FINAL DRAINAGE PLAN AND REPORT

MURR SUBDIVISION

PCD File: MS231

Revised
April 14, 2023

**DEVELOPED CONDITIONS
DRAINAGE BASIN SUMMARY**

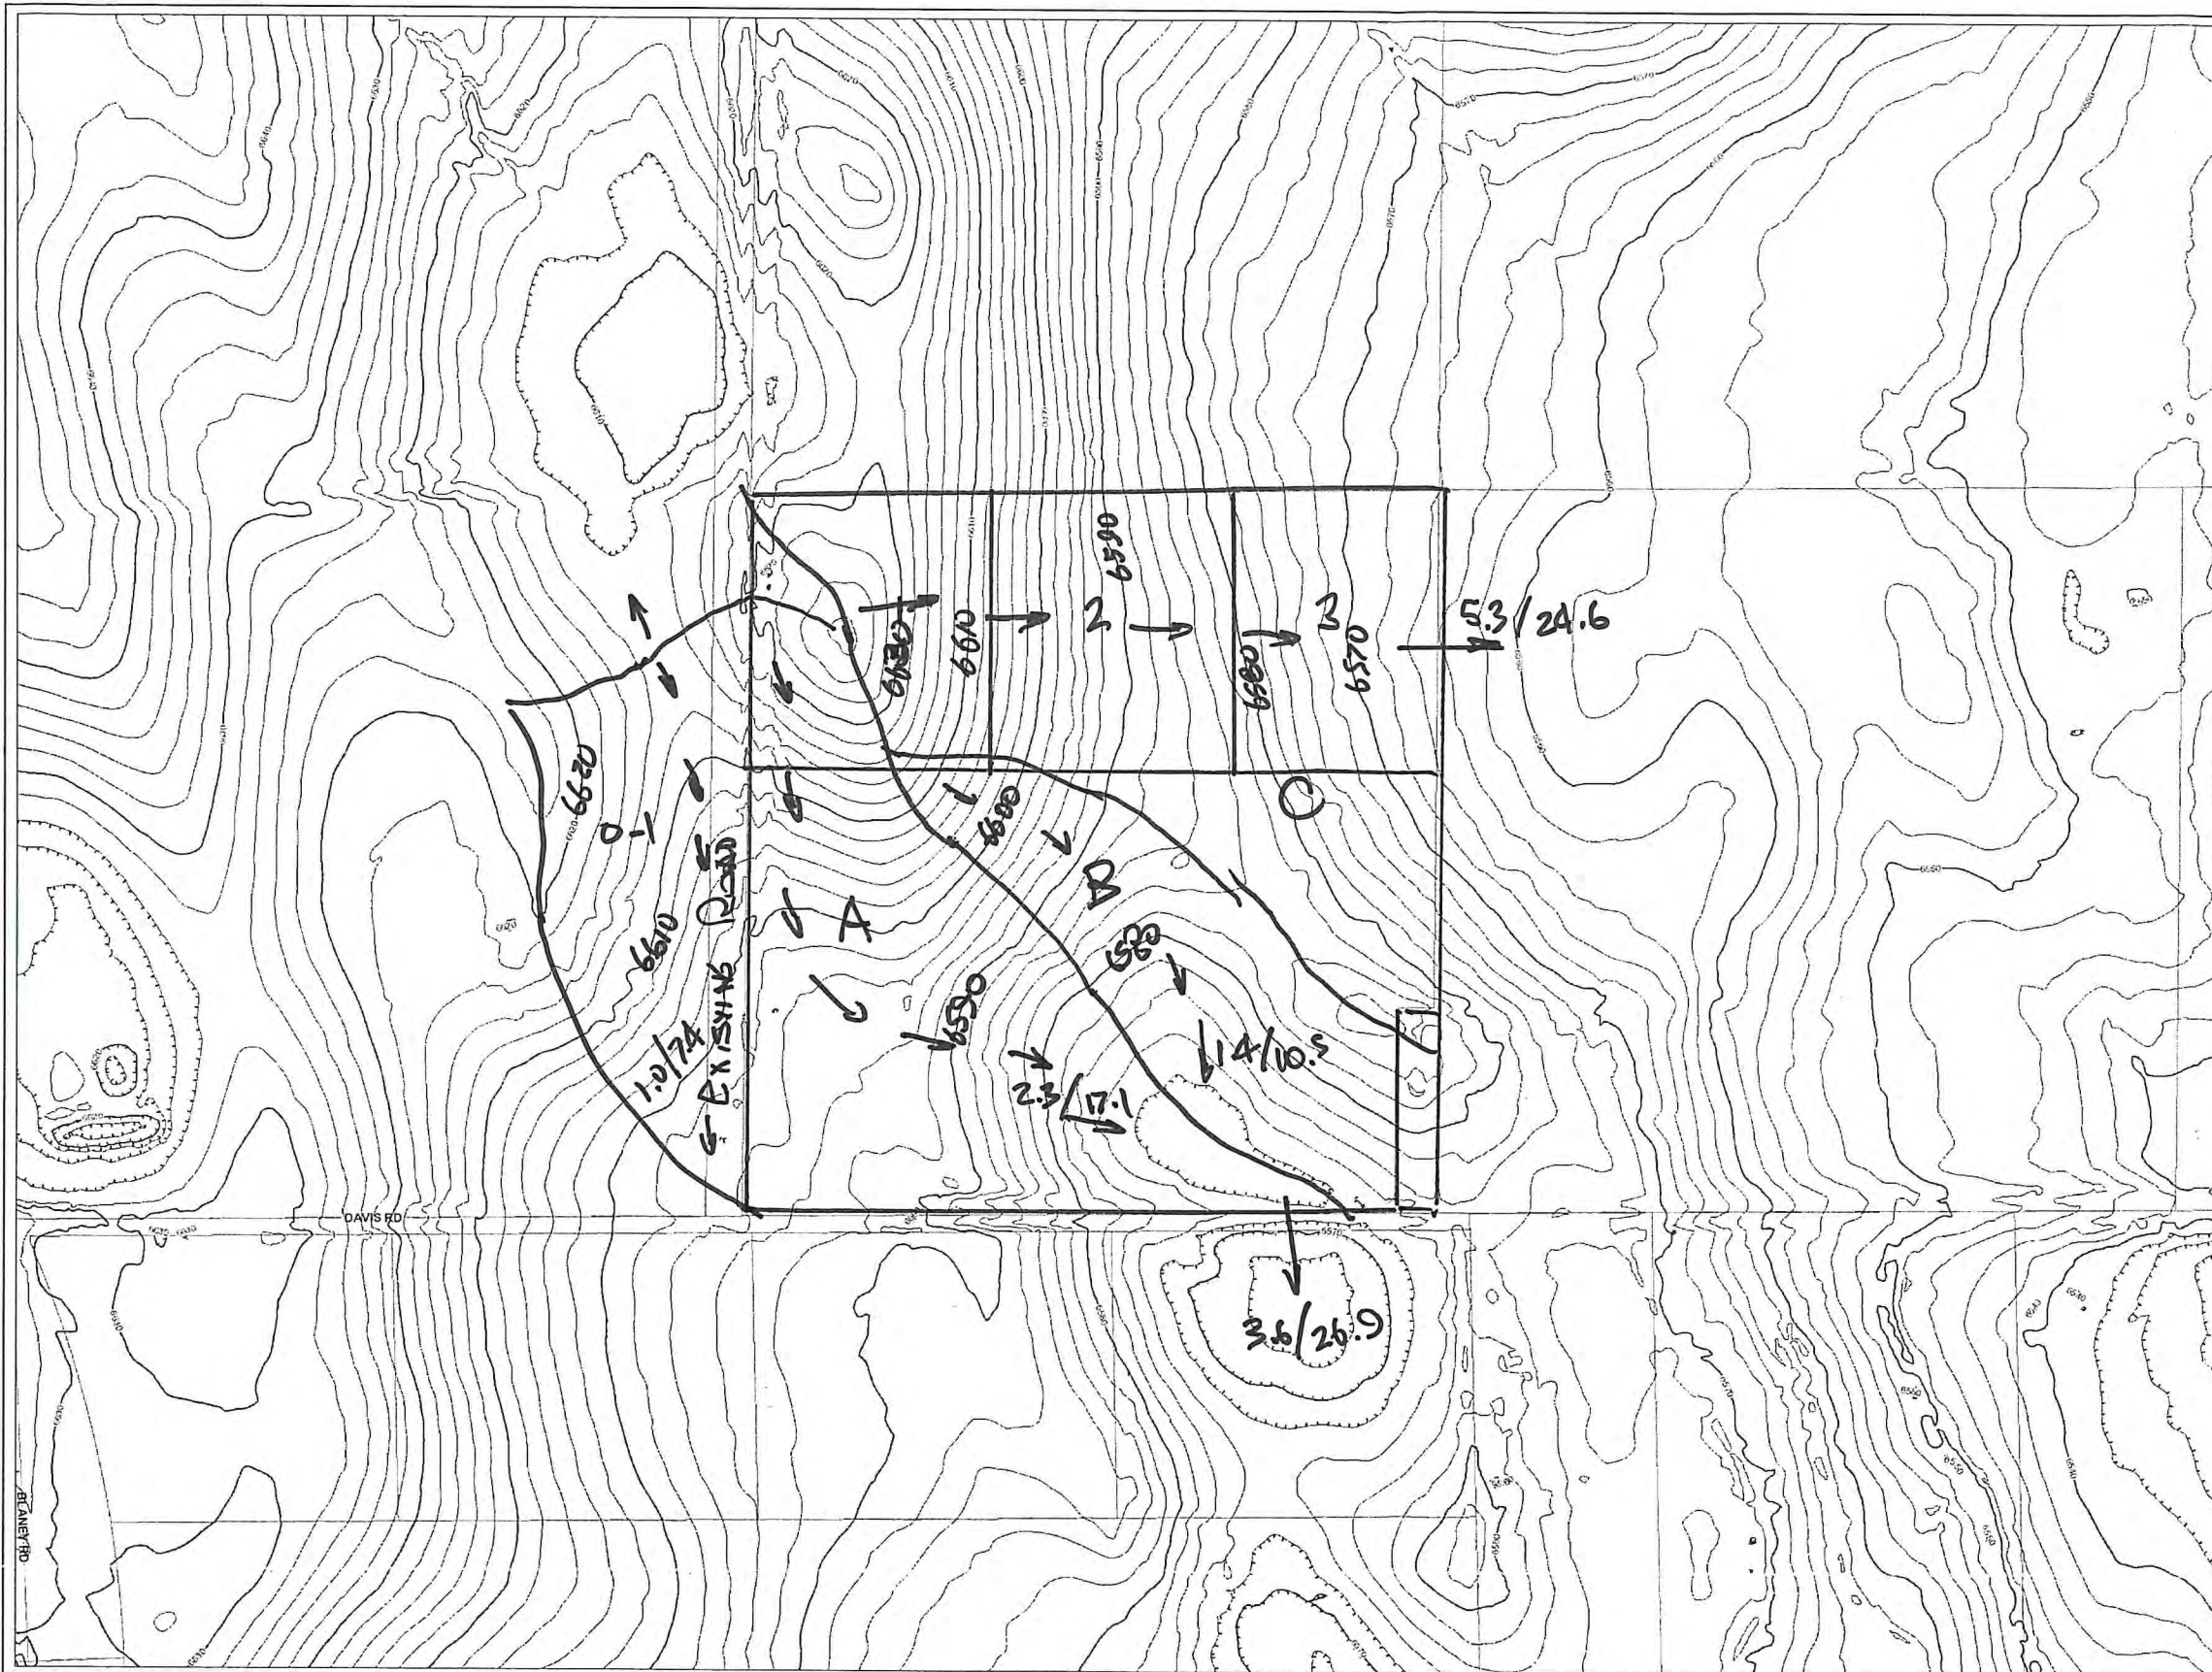
Flows significantly increase after development. Per unresolved comment on page 6, address whether detention is required because of runoff increase.
